T-815 Service Bulletin

| Subject: | Compressor Turbine (CT) Blade |
| EXTEX Part Numbers: | E3045741-01 revision D (or prior) |
| Description: | This service bulletin provides instructions for inspection and disposition of the subject CT blades. |

Figure 1

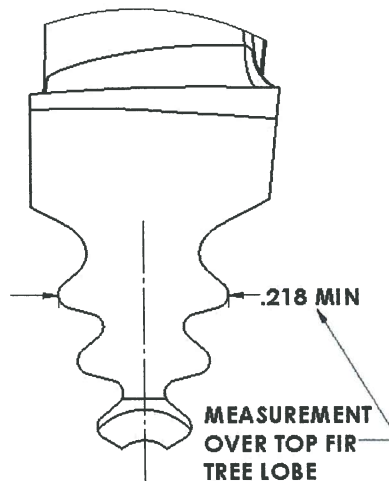
| Accomplishment Instructions: | When blades are removed from disk, measure over the top lobes as shown in Figure 1. Scrap any blades that measure less than 0.218 inch. Record compliance with this service bulletin indicating inspection or removal in the applicable section of the engine log book. The entry should include the part number and a reference to EXTEX SB T-815. |
